CITY OF CEDAR RAPIDS
ImOn ICE ARENA REPAIR PROJECT - PHASE II
CEDAR RAPIDS, IOWA
PROJECT # #PUR0920-071

NO.	DATE	DESCRIPTION	BY	DWN
0	1-15-2021	OUT FOR BID DRAWINGS	MNA	JJH
1	2-1-2021	ADDENDUM #1	MNA	JJH
2	2-3-2021	ADDENDUM #2	MNA	JJH

NO.	DATE	DESCRIPTION	BY	DWN
0	1-15-2021	OUT FOR BID DRAWINGS	TMA	TAM
1	2/3/2021	ADDENDUM 2	TMA	TAM

FIRST FLOOR PLAN
SCALE: 1"=20'-0"

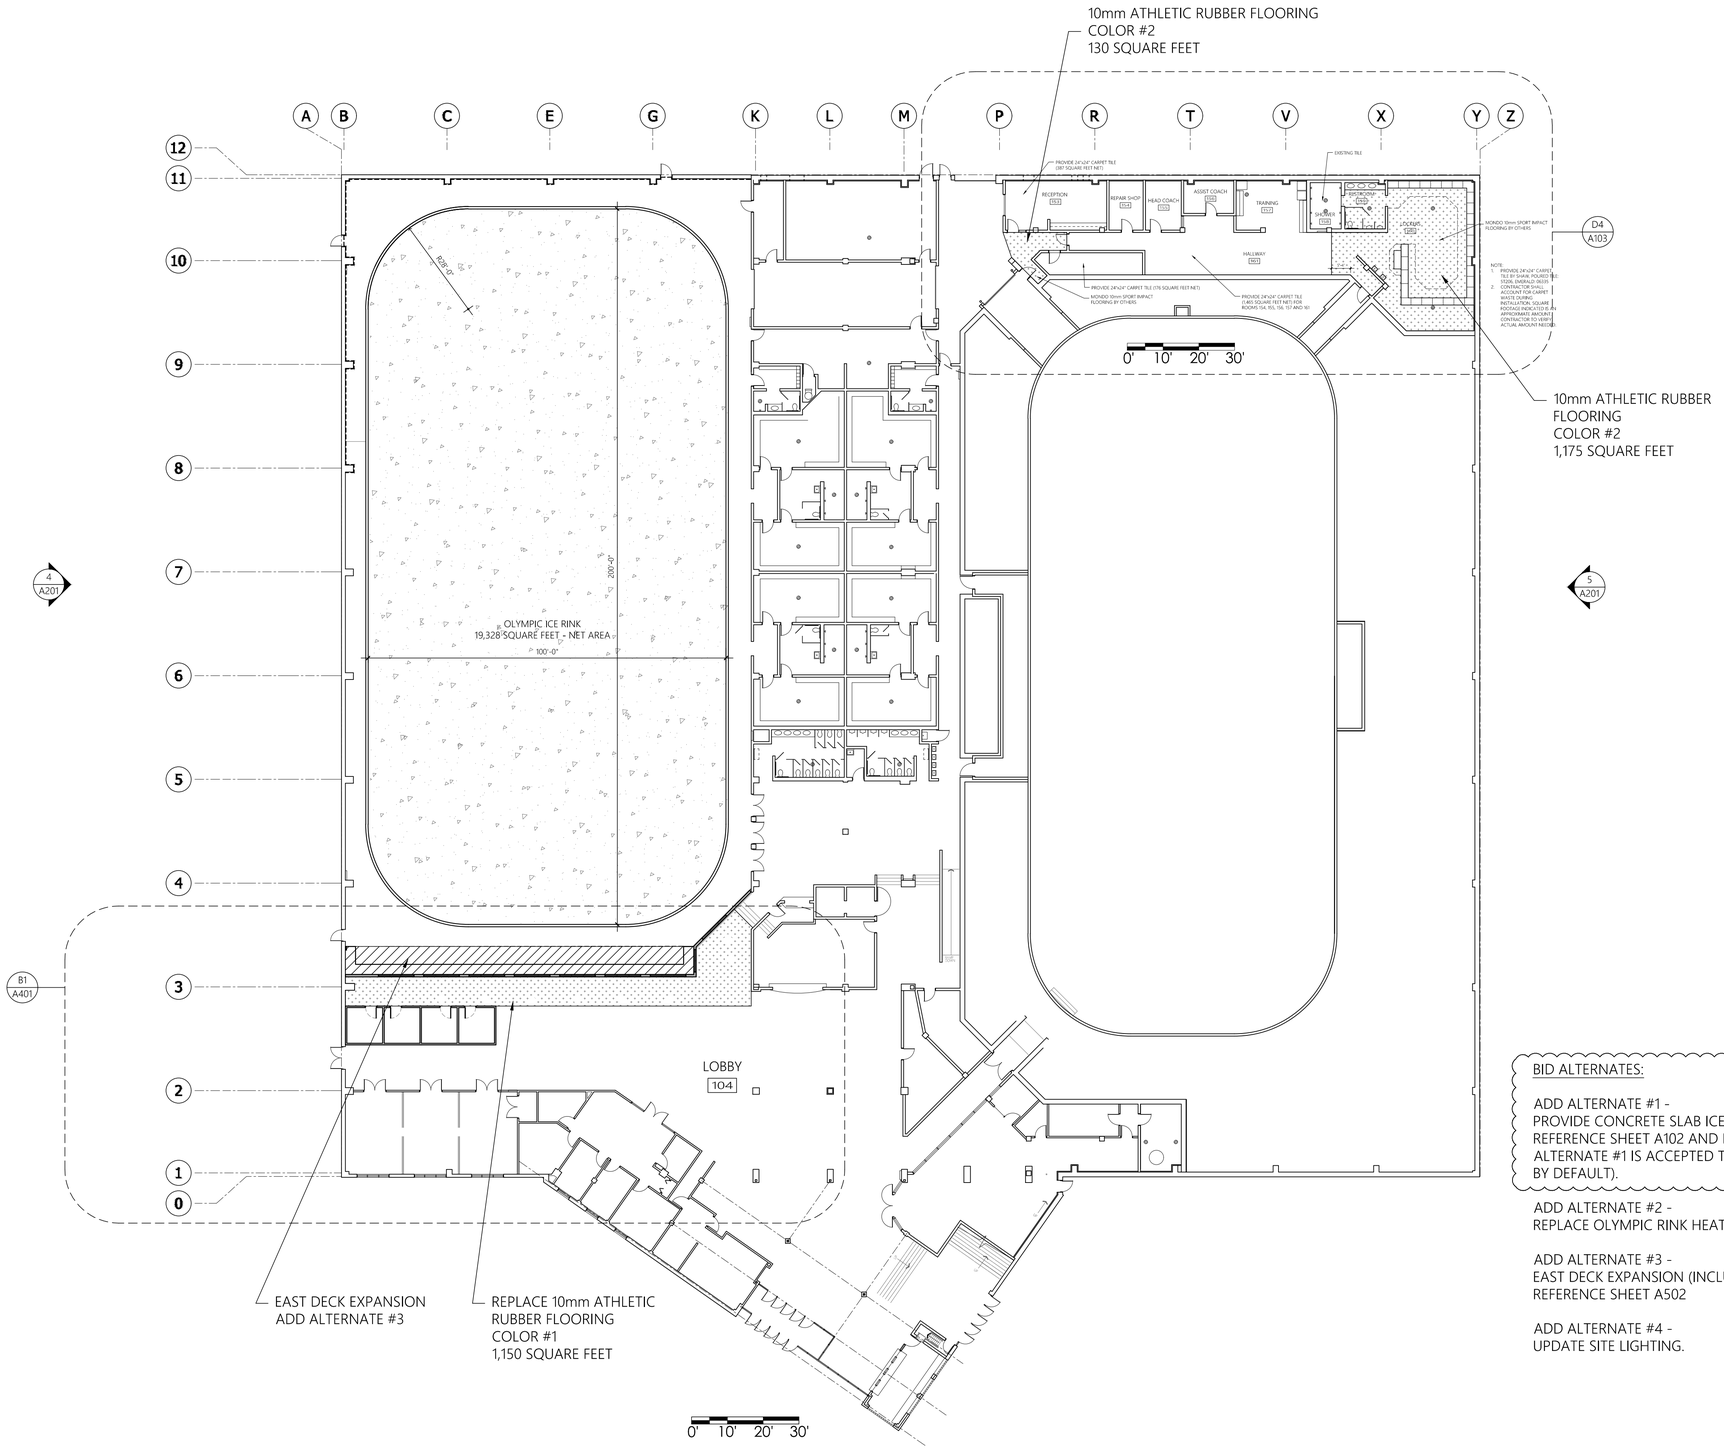
ADD ALTERNATE #1 -
PROVIDE CONCRETE SLAB ICE RINK SYSTEM FOR THE OLYMPIC ICE RINK. REFERENCE SHEET A102 AND DETAIL B3 AND B2 ON SHEET A501. (IF ADD ALTERNATE #1 IS ACCEPTED THEN ADD ALTERNATE #2 WILL BE REJECTED BY DEFAULT).

A HD02 **HIGH ROOF - HVAC DEMO PLAN**

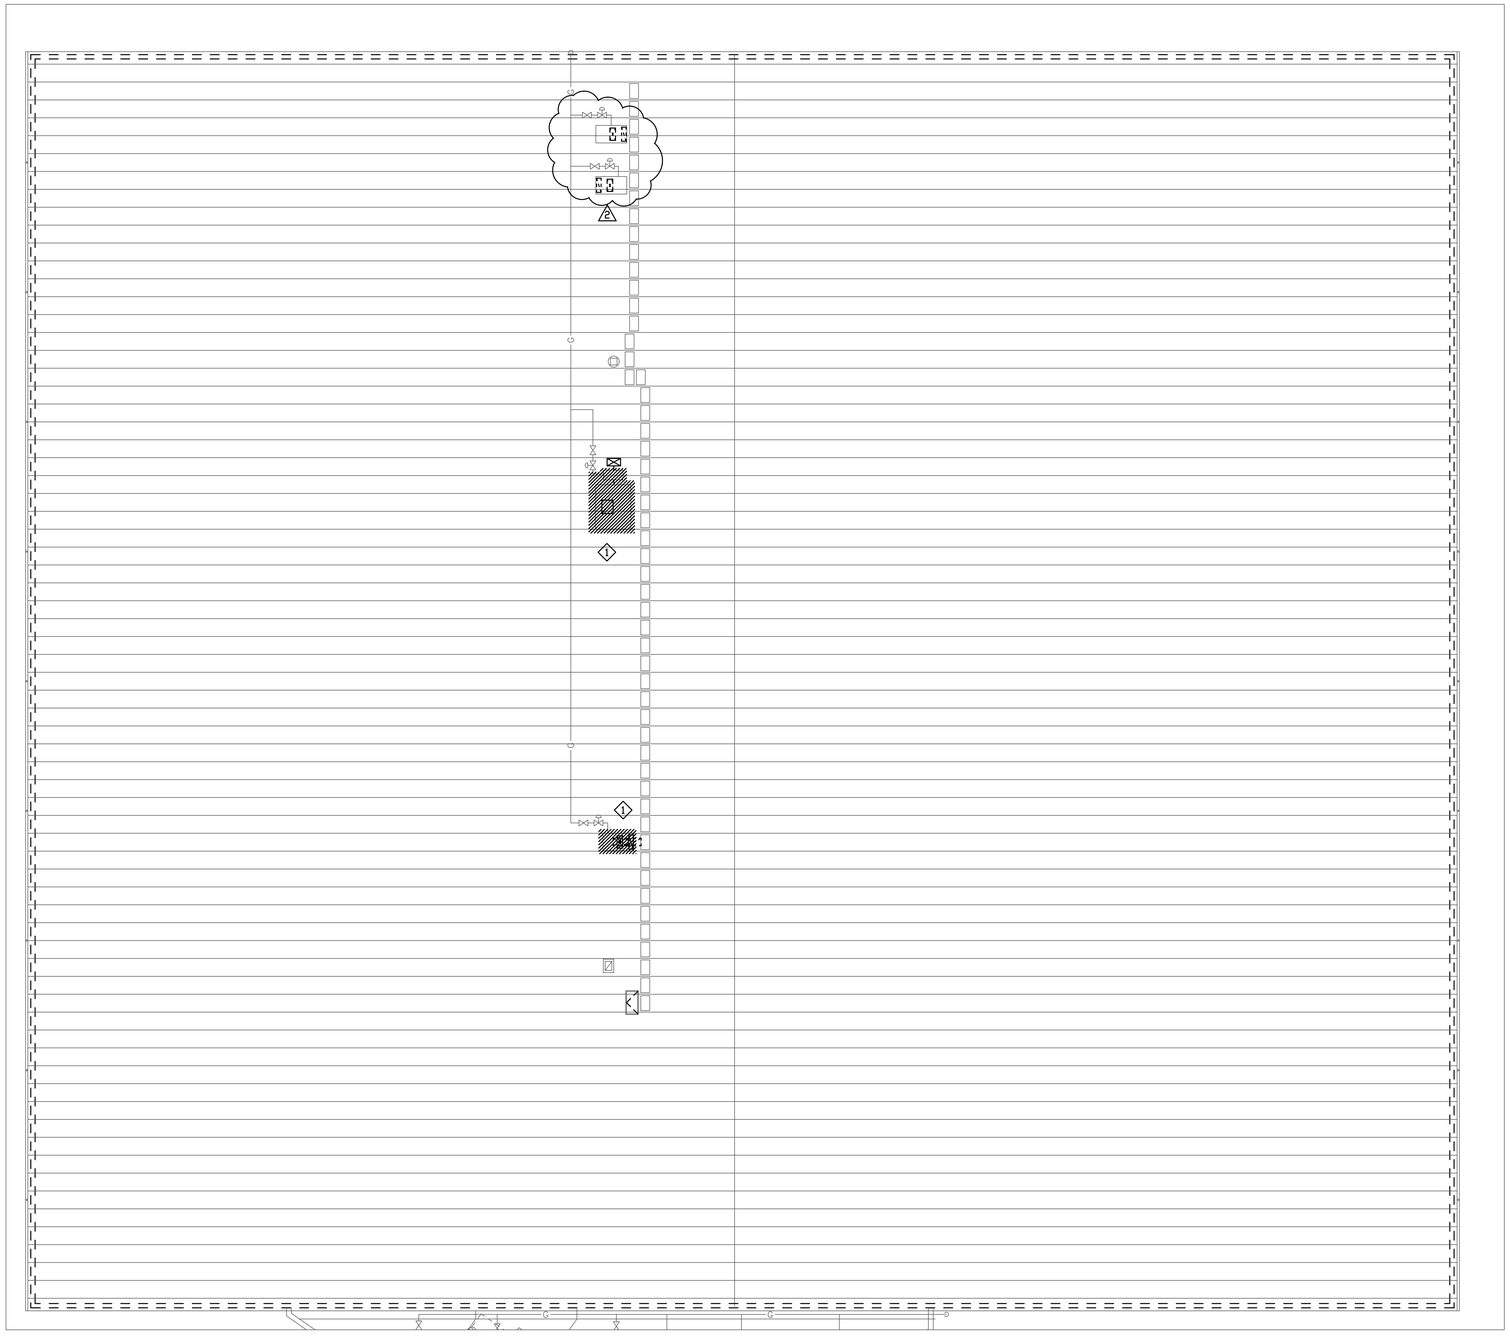
1. ~~REMOVE NEW ROOFTOP UNITS AND MOUNTING CURBS. COORDINATE WITH ROOFING CONTRACTOR PRIOR TO FACILITY RE-ROOFING. COORDINATE WITH MECHANICAL CONTRACTOR FOR INFRASTRUCTURE IMPROVEMENT PROJECT. ROOFTOP UNITS, CURBS, AND CONNECTED DUCTWORK TO BE PROTECTED DURING REMOVAL AND PREPARED FOR REINSTALLATION FOLLOWING RE-ROOFING.~~

West two units are in Phase 1 scope. Protect from damage during Phase 2 construction.
Sub-contract with Infrastructure Improvement project mechanical contractor to remove remaining rooftop units to allow re-roofing

1 H02 HIGH ROOF - HVAC PLAN

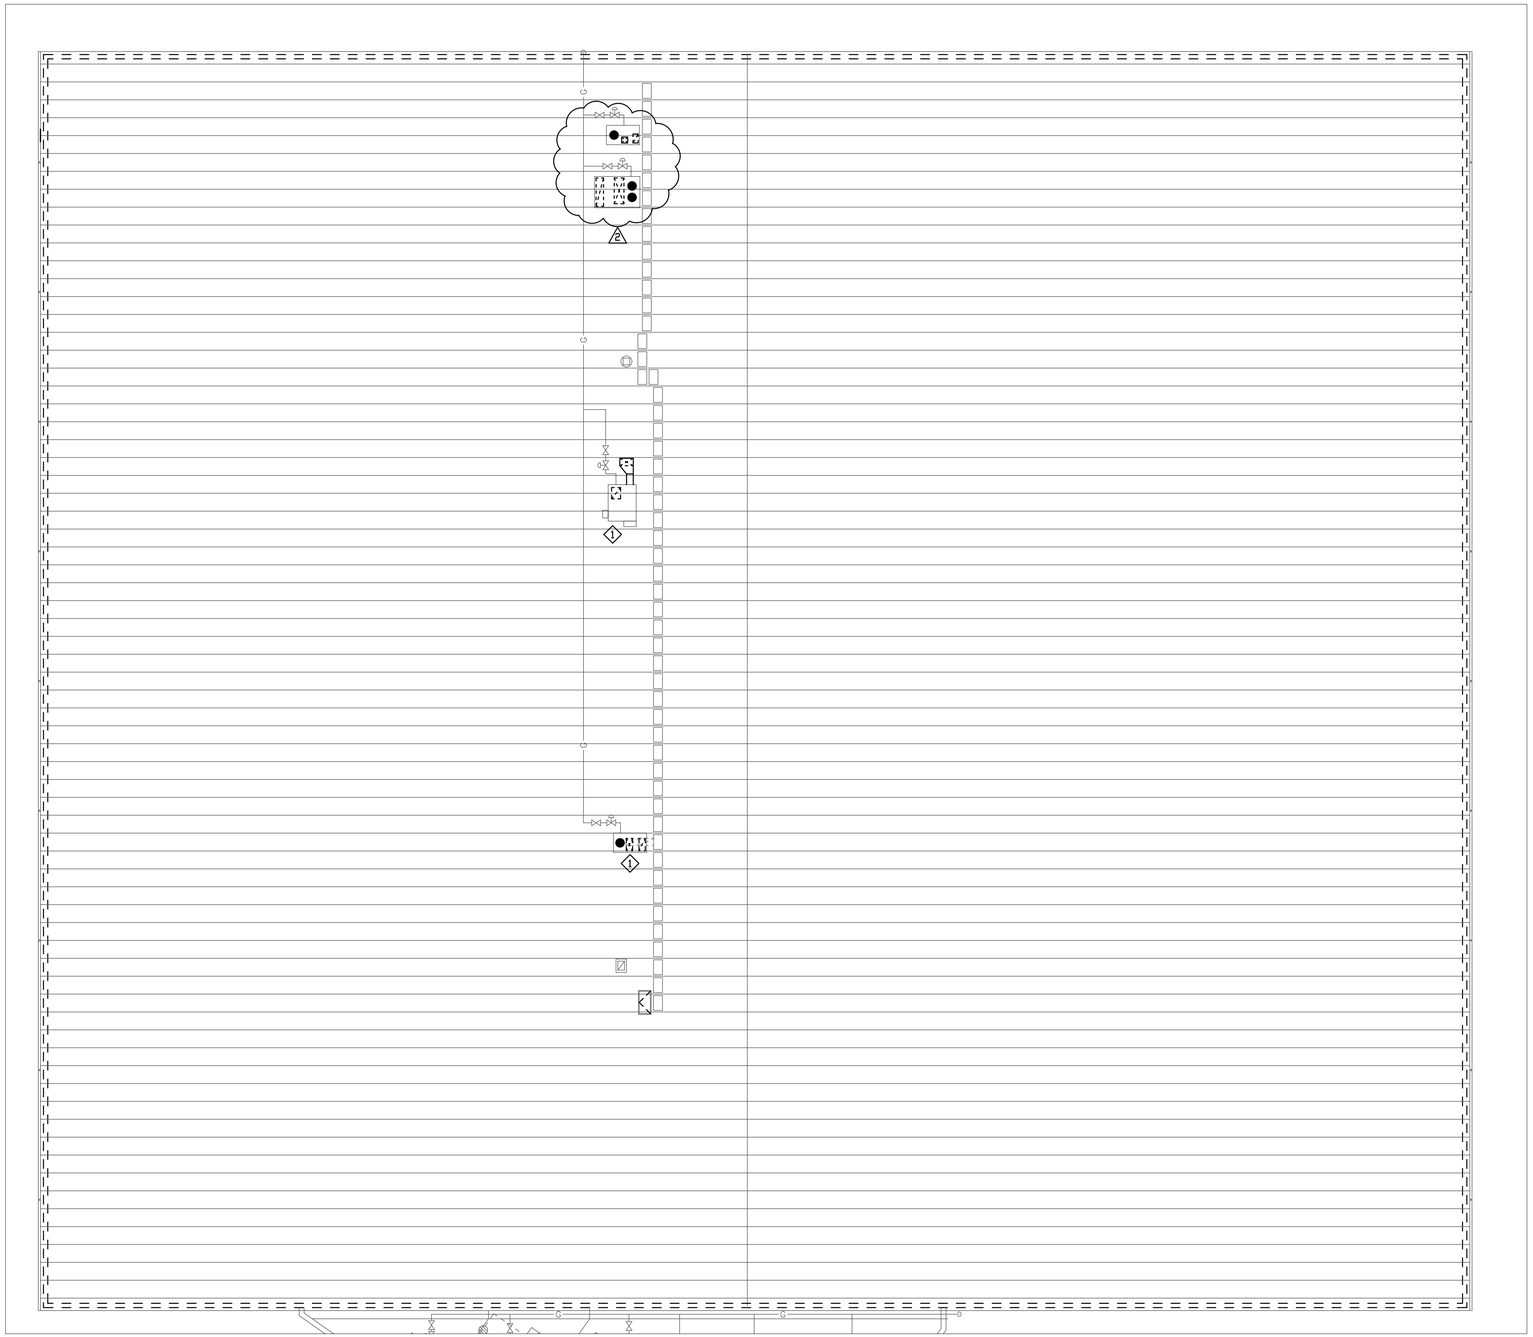
1. COORDINATE REINSTALLATION OF ROOF CURBS AND RTU'S WITH M.C. FOR INFRASTRUCTURE IMPROVEMENT PROJECT AND ROOFING CONTRACTOR. REINSTALLATION TO COINCIDE WITH INSTALLATIONS OF NEW ROOF.
2. Rooftop unit replaced during Phase I construction. Protect from damage during Phase 2 construction work.

1 MD01 OLYMPIC ICE RINK - DEMOLITION PLAN

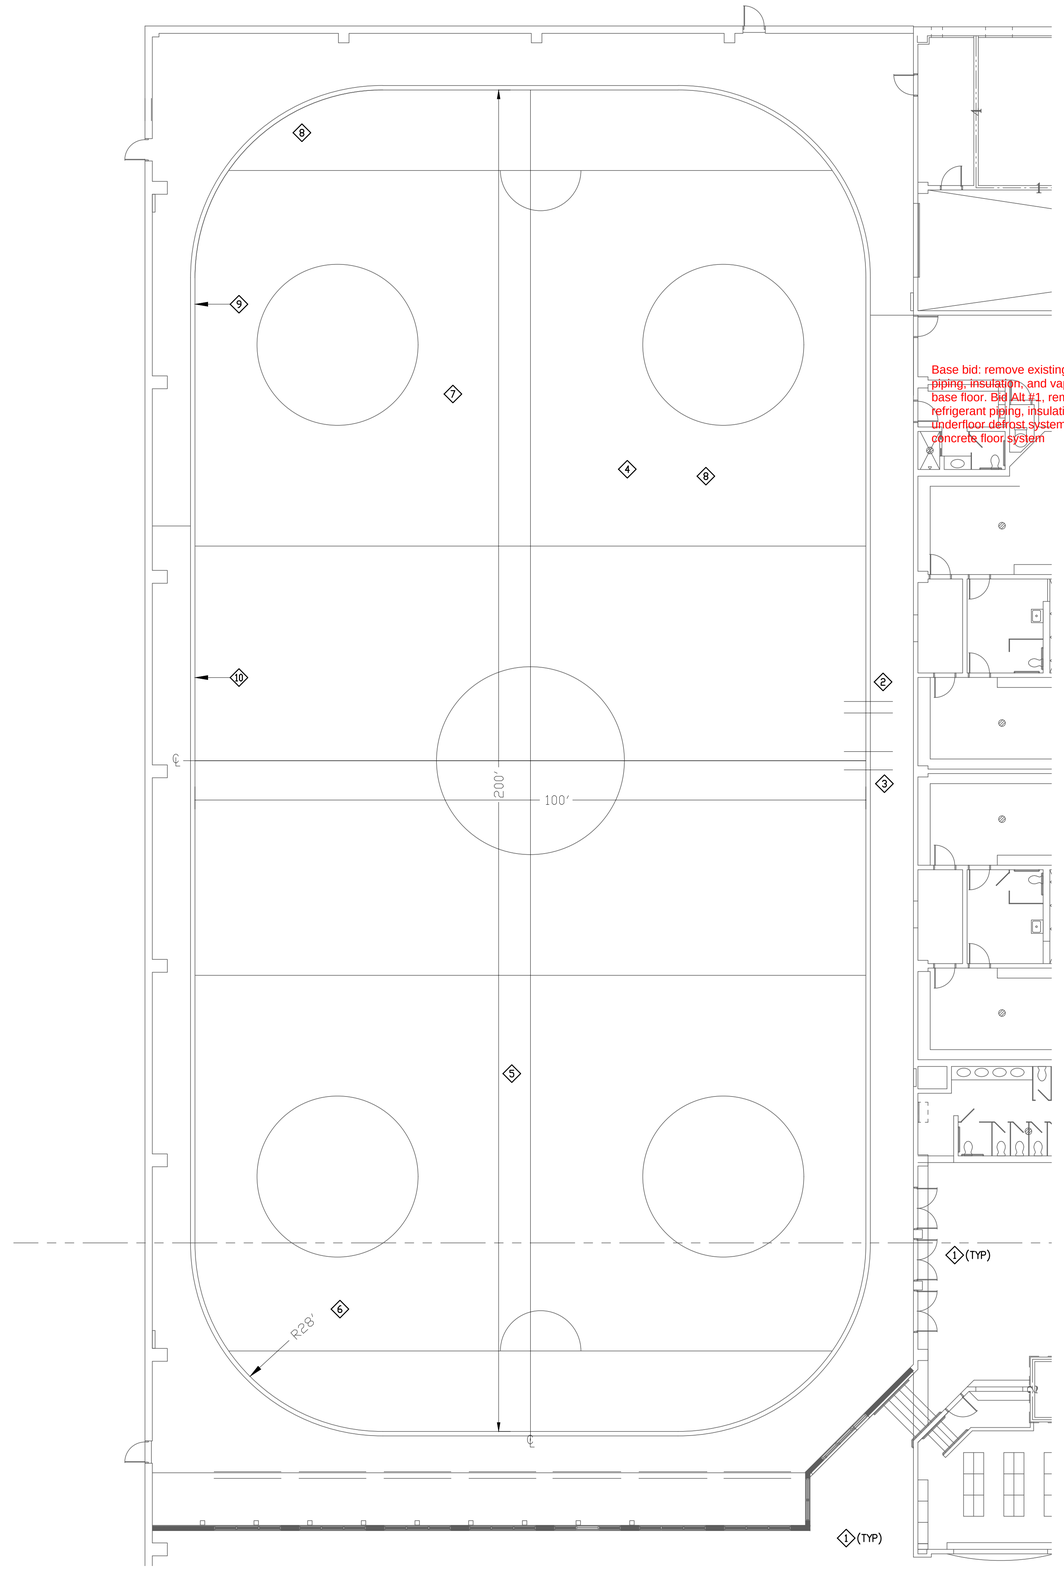
Base bid: remove existing sand floor base, brine refrigerant piping, insulation, and vapor barrier for replacement with sand base floor. Bid Alt #1, remove existing sand floor base, brine refrigerant piping, insulation, vapor barrier, and existing underfloor defrost system for replacement with complete concrete floor system

4. ~~MAIN BID AND BID ALT 1, REMOVE EXISTING SAND FLOOR BASE BRINE REFRIGERANT PIPING, INSULATION, AND VAPOR BARRIER.~~
5. BID ALT 2, REMOVE AND REPLACE EXISTING SUBGRADE HEATING LOOP.
